RE: THE AMERICAN PUBLIC POWER ASSOCIATION’S COMMENTS ON THE ENVIRONMENTAL PROTECTION AGENCY’S PROPOSED FEDERAL IMPLEMENTATION PLAN ADDRESSING REGIONAL OZONE TRANSPORT FOR THE 2015 OZONE NATIONAL AMBIENT AIR QUALITY STANDARD; 87 Fed. Reg. 20,036 (April 6, 2022); Docket ID No. EPA-HQ-OAR-2021-0668

COMMENTS OF THE AMERICAN PUBLIC POWER ASSOCIATION
on the
FEDERAL IMPLEMENTATION PLAN ADDRESSING REGIONAL OZONE
TRANSPORT FOR THE 2015 OZONE NATIONAL AMBIENT AIR QUALITY
STANDARD; PROPOSED RULE
87 Fed. Reg. 20,036 (April 6, 2022); Docket ID No. EPA-HQ-OAR-2021-0668
June 21, 2022

Figure 4-1. 2021 Average Ozone Season NOx Emissions: Tangential-Fired Boilers Firing Bituminous, Subbituminous, Blends and Lignite Coals

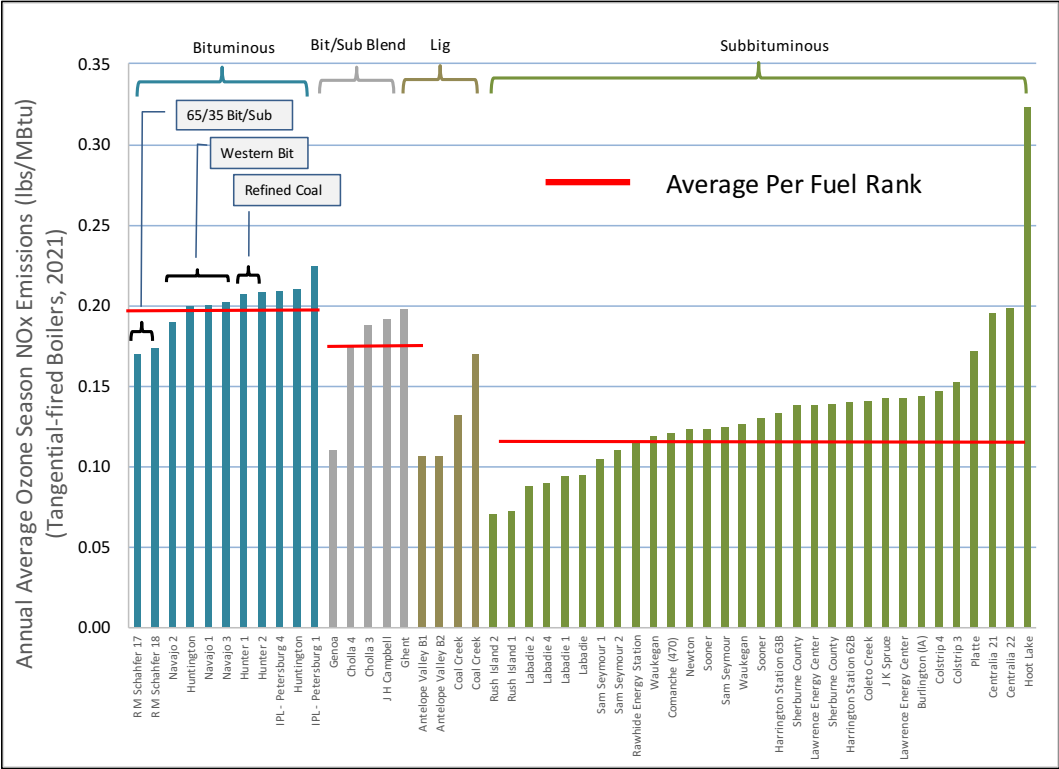
Figure 4-1 reports NO_x data for 11 tangential-fired units designated by EPA as firing bituminous coal, with the results suggesting approximately 0.20 lbs/MBtu as achievable. This depiction is inaccurate, as the fuels as reported by EPA as bituminous are misleading. Based on EIA Form 860 data for 2020, the RM Schaffer units fire a bituminous/subbituminous blend. The Navajo and Hunter units fired western bituminous – the composition of which lacks the sulfur content and acid/base ratio of eastern bituminous coals that are problematic in achieving the deep staged conditions required for low NO_x. Also, differences in coal nitrogen content and the inherent volatility assert an impact. The Hunter units fire a refined variant of bituminous coal – an option not available in 2022. Only IPL-Petersburg Units 1 and 4 fire an authentic bituminous coal of composition that could be considered representative of U.S. fuels. Further, EPRI estimates the median value of NO_x emissions from tangential-fired boilers firing bituminous coal to be 0.35 lbs/MBtu for LNCFS-II and 0.34 lbs/MBtu for LNCFS-III, with values for the latter option as high as 0.47 lbs/MBtu.⁹ This information – albeit derived from a 2003 summary – reflects the present status of technology cited by EPA, as the NO_x emission rates less than 0.10 lbs/MBtu were publicly cited in 2000.¹⁰

Figure 4-2. 2021 Average Ozone Season NOx Emissions: Wall-Fired Boilers Firing Bituminous, Subbituminous, Blends and Lignite Coals

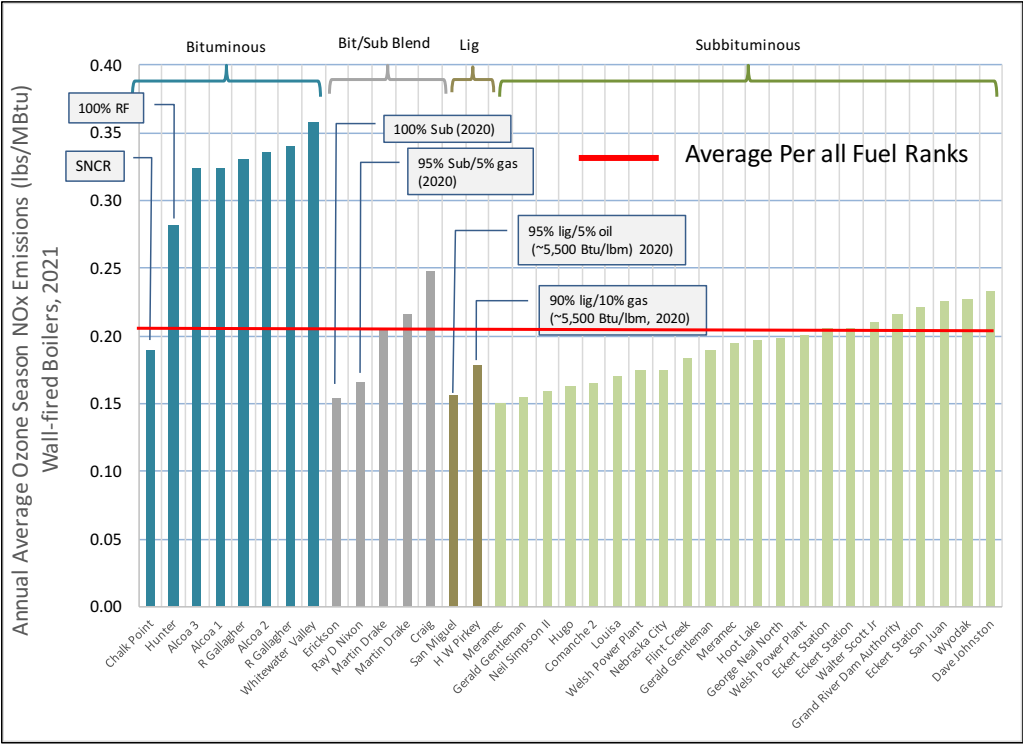
Figure 4-2 reports NO_x data for eight wall-fired boilers EPA cites as firing bituminous coal, with the results suggesting NO_x emission less than 0.20 lbs/MBtu as achievable. As noted

Figure 5-1. Capital Cost vs Capacity Relationship for SCR NOx Control: Coal and Distillate Oil/Natural Gas

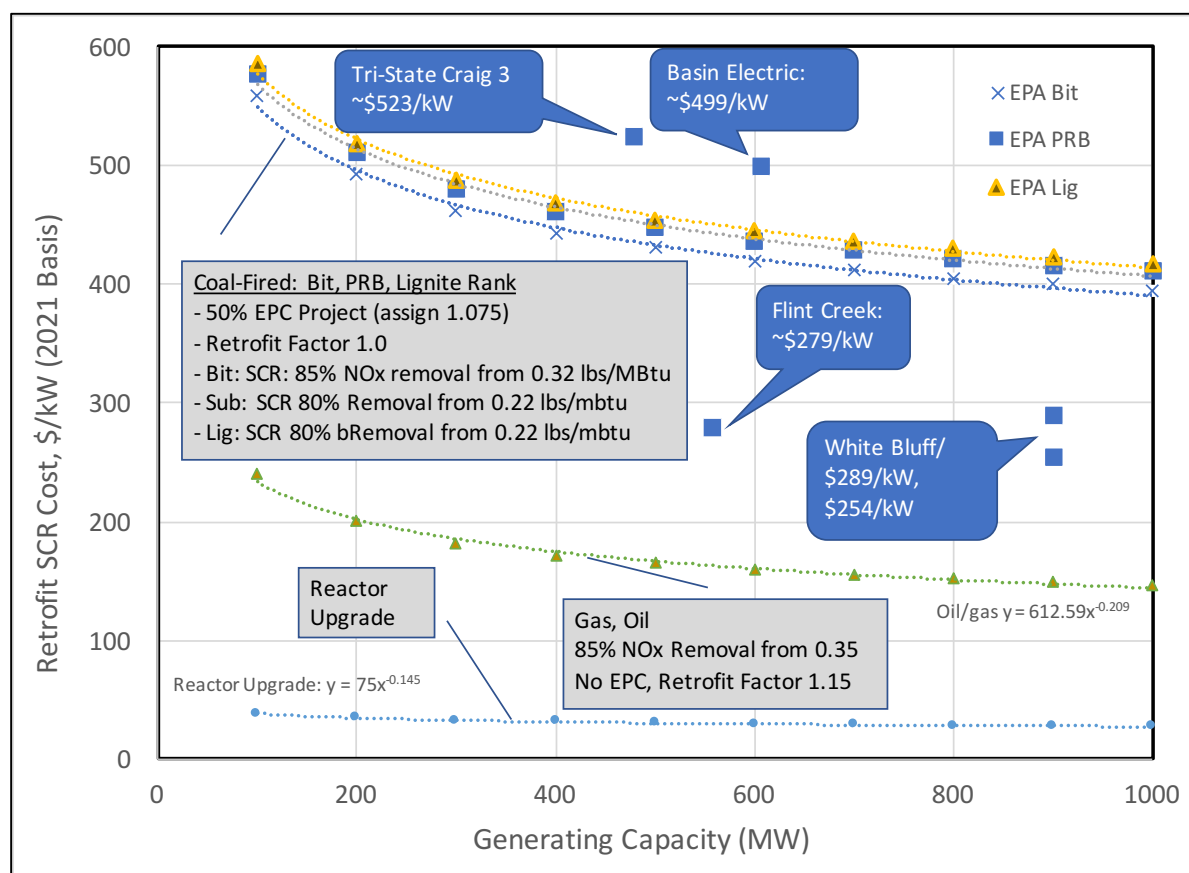
Figure 5-1 shows the cost correlation well-reflects four estimates recently prepared for project participants. That a factor-of-two variation observed between several of the estimates (Flint Creek, Craig Unit 3) is not unusual –industry experience shows such variations are not uncommon, due to varying site conditions. (Such variations are the rationale for the "Retrofit Factor", subsequently described).

Figure 5-1 presents SCR capital costs for units firing these three ranks of coal. The SCR process conditions and the percent NOx removal required are inputs to the Retrofit-Cost-Analyzer-Update-1-26-2022 to generate capital cost. For bituminous units, a boiler NOx rate of 0.32 lbs/MBtu is assumed, targeting 85% reduction. For both PRB and lignite fuel ranks, a boiler NOx rate of 0.22 lbs/MBtu is assumed, targeting 80% NOx reduction

Also included in Figure 5-1 is a cost of \$25/kW assumed necessary for pre-2005 SCR reactors to refurbish existing catalyst, retrofit enhanced catalyst cleaning devices (to remove accumulated fly ash deposits), and where necessary retrofit improved reagent mixing and flue gas rectification hardware (to improve flow velocity entering the SCR reactor). These or similar modifications will be necessary for pre-2005 SCR reactors to accommodate the changes proposed by EPA.

Figure 5-4. Timeline for Engineering, Procurement, and Installation of SCR Postcombustion Control Technology

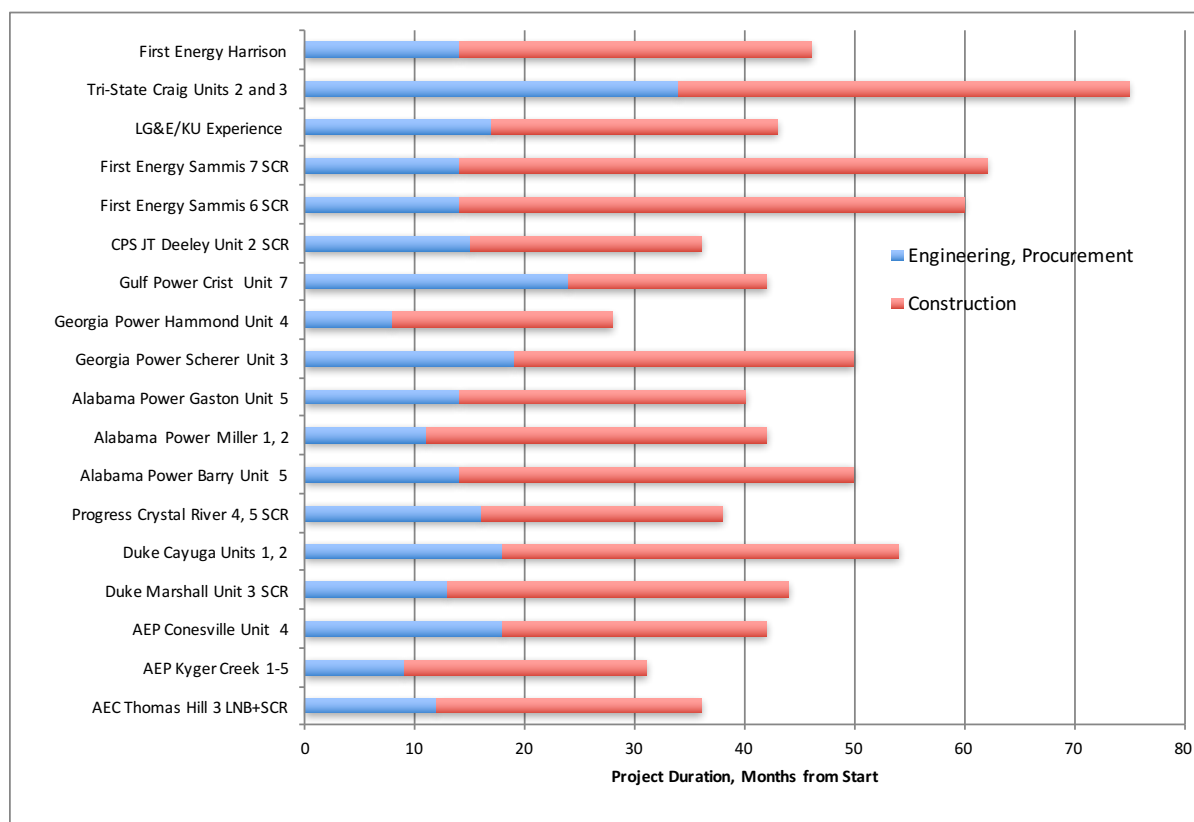
Figure 5-4 presents installation schedule information for 18 SCR installations, as managed by ten owners. These data capture all project aspects from planning, conceptual engineering, RFP development, proposal solicitation and review, contract award and negotiation, hardware fabrication and installation. Figure 5-3 shows the typical time required for a single SCR reactor is 40 months, while retrofit of multiple reactors to one site requires 45 months. These authentic, recorded schedules suggest that retrofit of the inventory of approximately 100 units with SCR technology is not feasible.

Figure 6-1. SCR Retrofit to Coal-Fired Units: Incurred Cost per Ton, 10-Year Basis

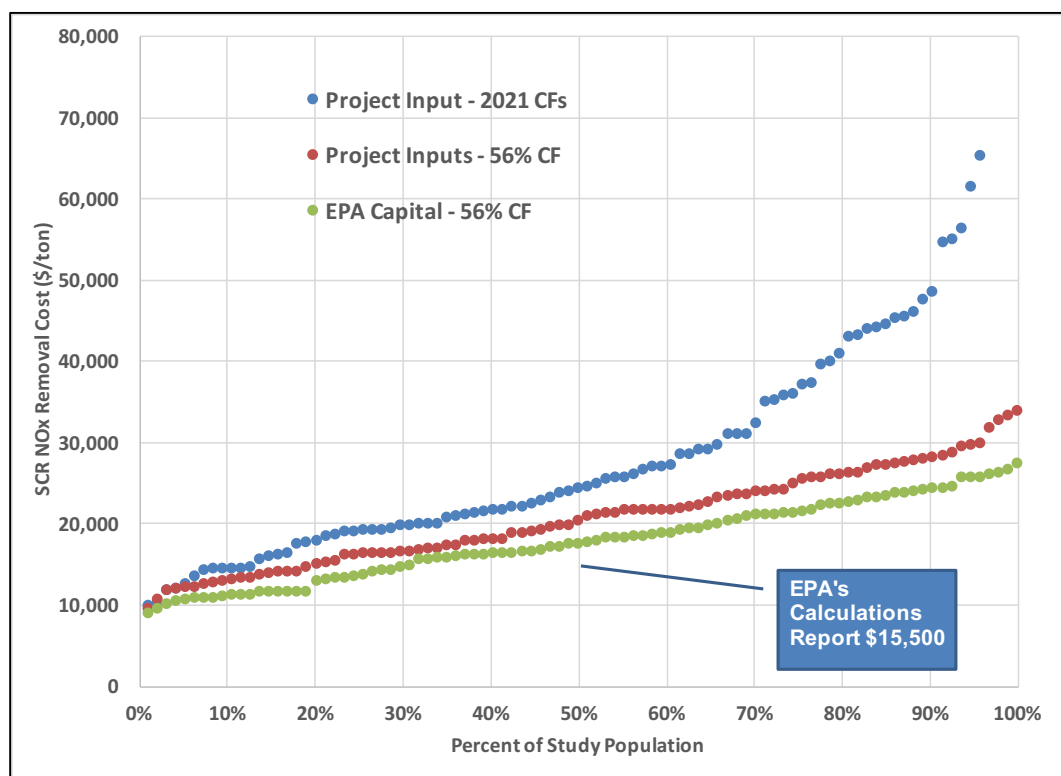
Figure 6-1 shows the median cost incurred for a unit to retrofit SCR where none had previously existed to be \$20,250 per ton for operation at 56% capacity factor, while 90% of units in the population will incur a cost not more than \$28,103 per ton. The analysis was also conducted for each generating unit using their unique 2021 capacity factor, with results showing the median cost for the population to be \$24,340 per ton, while 90% of units in the population will incur a cost not more than \$50,000 per ton.

Figure 6-2. SCR Retrofit to Coal-Fired Units: Incurred Cost per Ton, 5-Year Basis

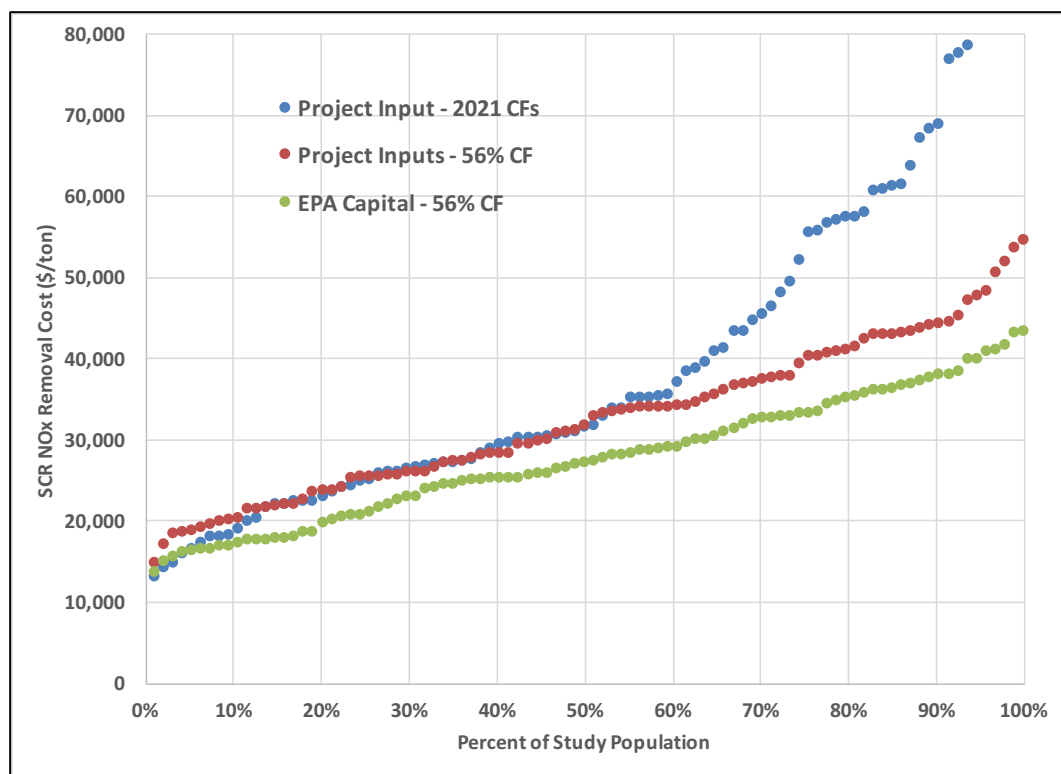
Figure 6-2 shows the decrease in lifetime from 10 to 5 years significantly increases cost. The incurred cost for a unit at the median population is projected to be \$31,663 per ton for operation at 56% capacity factor, escalating to approximately \$44,286 per ton for a unit at the 90% population. For operation at the 2021 capacity factor, the analysis shows the cost for the median population to be nearly identical at \$32,286 per ton, while 90% of units in the population will incur a cost not more than approximately \$70,000 per ton. The 5-year lifetime approximately doubles incurred costs.

Figure 6-7 Incurred Cost per Existing SCR to Achieve 0.08 lbs/MBtu

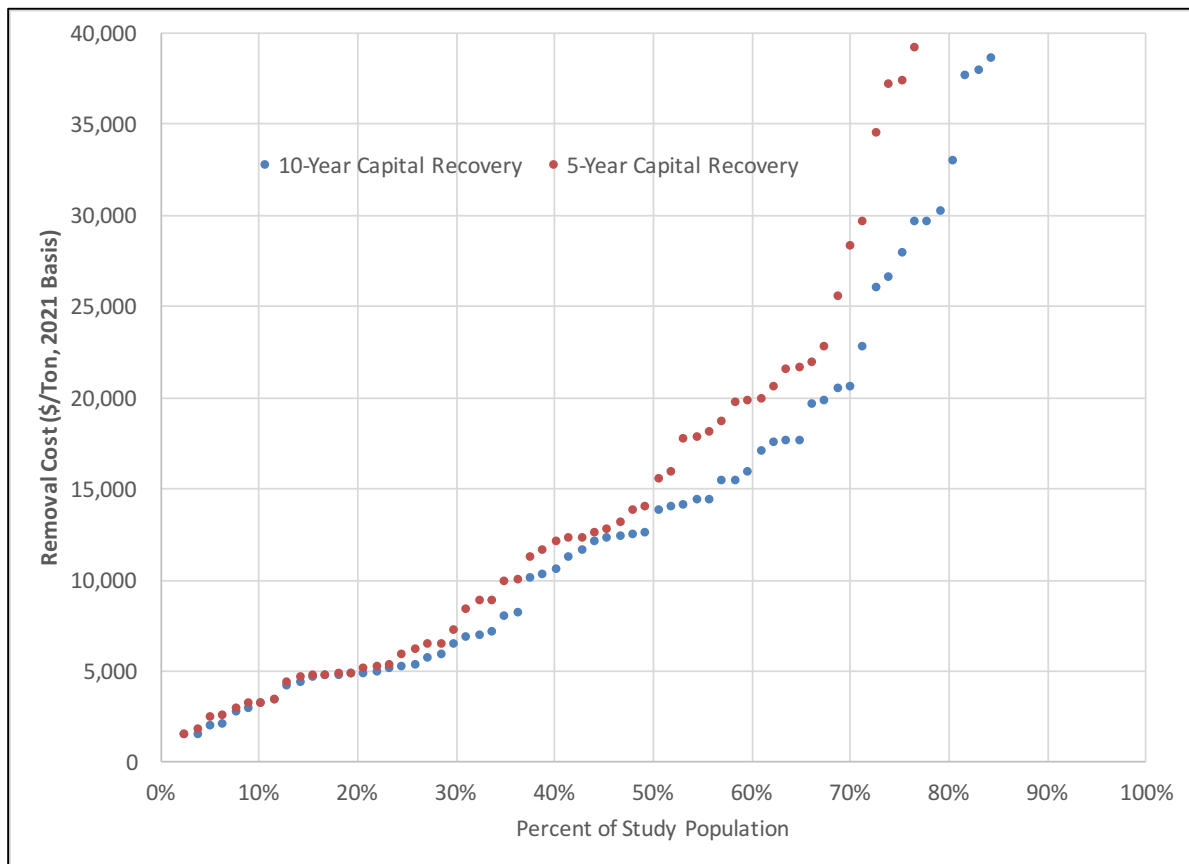
Figure 6-7 presents the true cost EPA should be using as the metric - the marginal cost for the incremental reduction in NO_x from the 2021 ozone season rate achieved by SCR. Absent EPA actions, this 2021 NO_x rate would continue – thus enhancing SCR performance to meet 0.08 lbs/MBtu (with margin) is an additional benefit. The methodology to determine this cost is the proper approach to value the cost of this aspect of the proposed rule.

Figure 7-2. LG&E/KU Mill Creek Unit 4 Startup Data

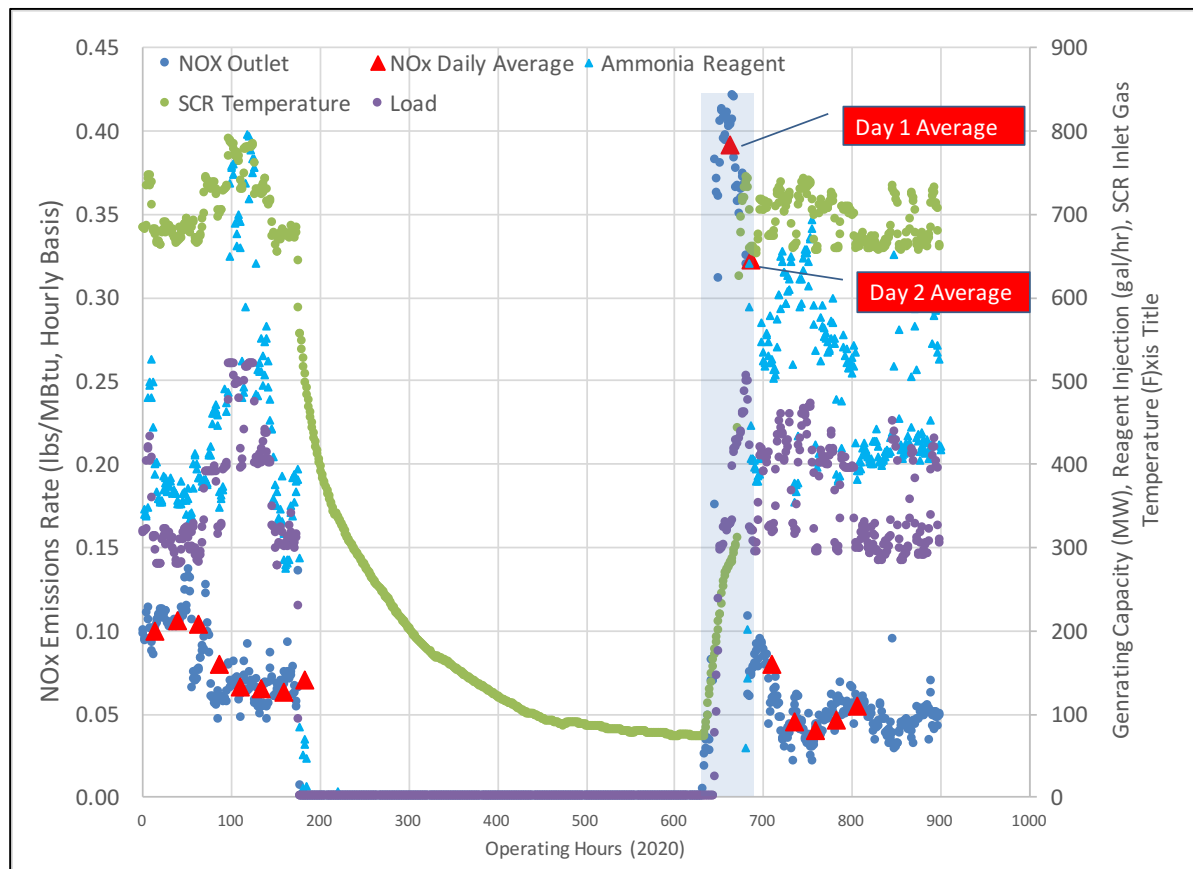
Figure 7-2 shows that at least for two boiler operating days following ammonia injection, the daily NO_x rate exceeds the proposed backstop value of 0.14 lbs/MBtu. Consistent with Figure 7-2, EPRI reports typical SCR startup periods are 7-24 hours, and impact the ability of the SCR process to effectively remove NO_x.³⁴

Figure 7-3. LG&E/KU Trimble County 2: Time Duration of SCR Startup Events

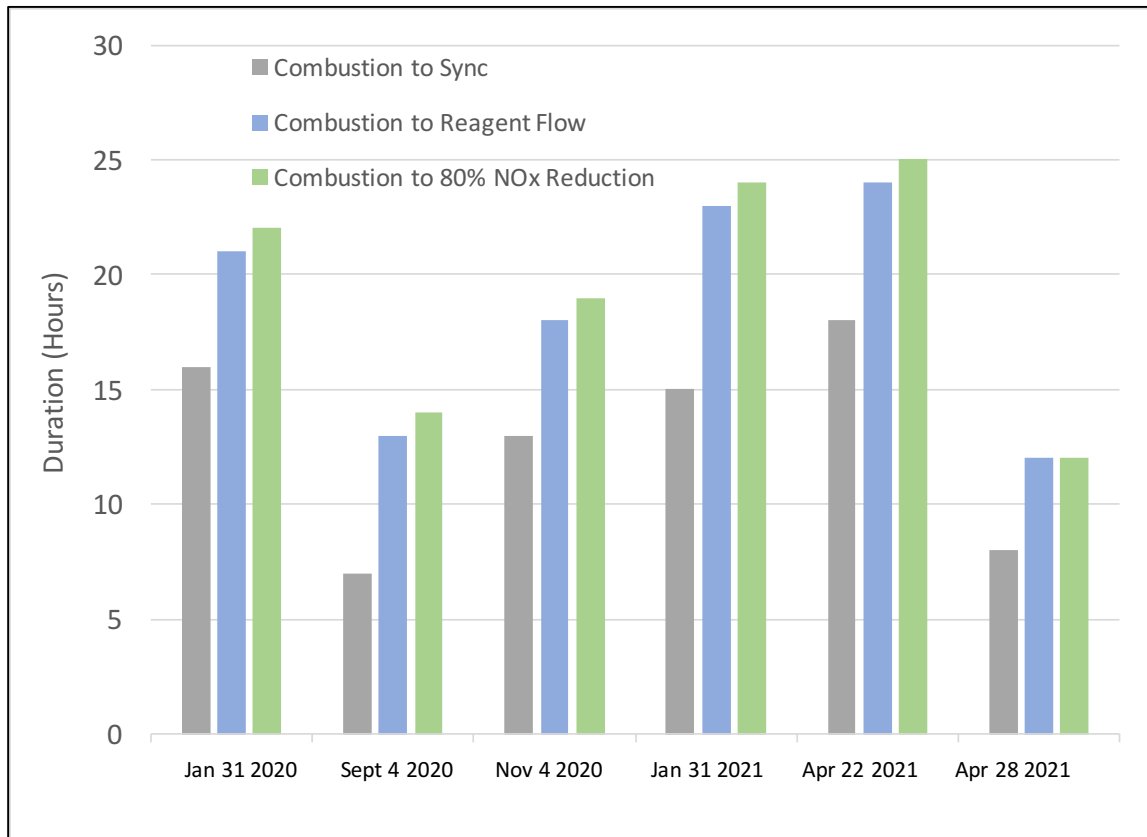
The key takeaway from Figure 7-3 is the time required for 80% NO_x reduction, which over six startup events ranges from 12 to 25 hours.

Figure 7-4. Count of Units Emitting Above Proposed Backstop Rate

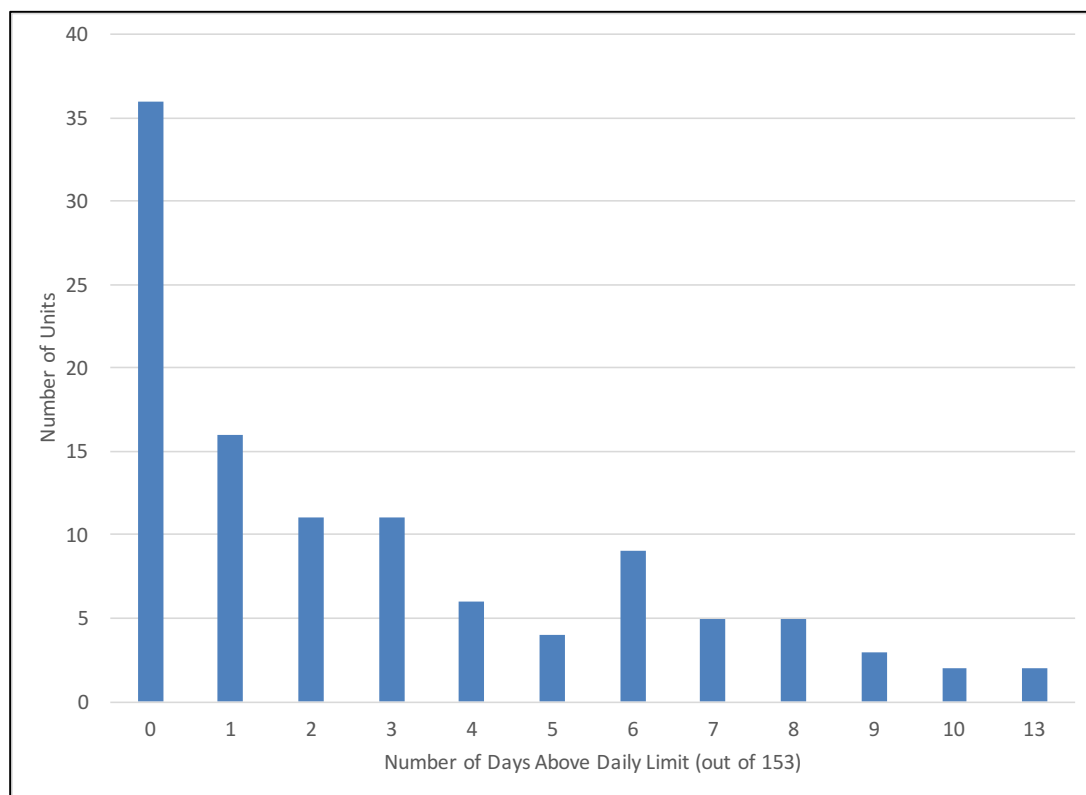
Count of Units with Daily Emissions Above the Proposed Backstop Rate. Figure 7-4 reports for the 110 units that achieved 80% NO_x reduction for the 2021 ozone season, the number of units for which NO_x is observed to exceed the proposed daily rate of 0.14 lbs/MBtu. Figure 7-4 shows about 1/3 of the total units in this population – 36 – do not experience excursions in NO_x daily rate exceeding the proposed 0.14 lbs/MBtu. The horizontal axis describes the increase in units that emit more than 0.14 lbs/MBtu, for multiple days. For example, eleven units operated above 0.14 lbs/MBtu for three days, while five units exceed that rate for 7 days.
